NORTHERN DISTRICT SEWERAGE SYSTEM
NORTHERN LINK AND TREATMENT PLANT
GUAM, MARIANA ISLANDS

OUTFALL SEWER AND DIFFUSER DETAILS

SIZE F | CODE IDENT NO 80091 | NAVFAC DRAWING NO 75-14-002
CONTR CONTRACT NO. 62786 74-C-0240
SCALE AS SHOWN | SPEC. 51-74-0240 | SHEET 20 OF 27

REVISED SECTION OF OUTFALL PIPE SHOWING DIFFUSER STAND-PIPE WITH CONCRETE ENCASEMENT

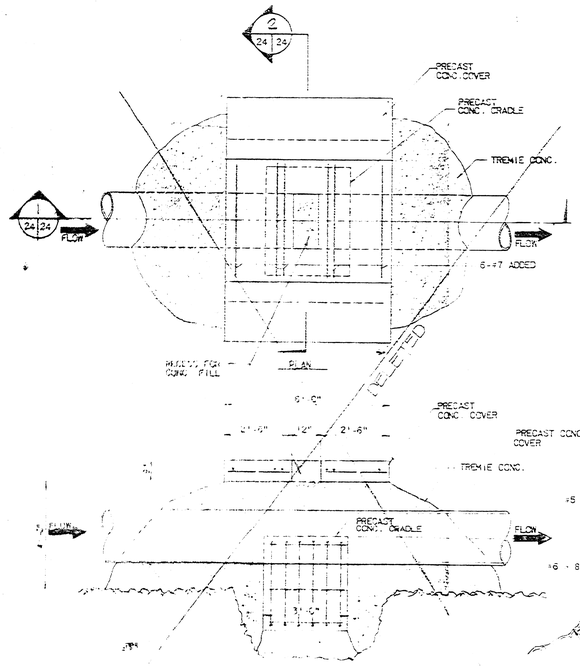
REVISED DIFFUSER PIPE DETAIL SEE REVISED SECTION

TYPICAL ANCHOR BLOCK DETAIL B
SCALE: 1/4" = 1'-0"

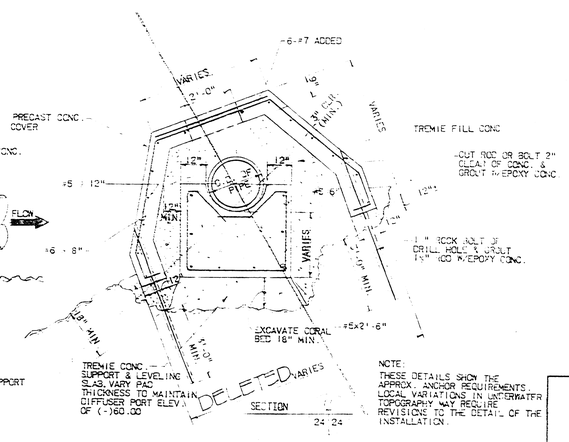
DELETED ANCHOR BLOCK DETAIL OUTFALL PIPE ENCASED IN CONCRETE
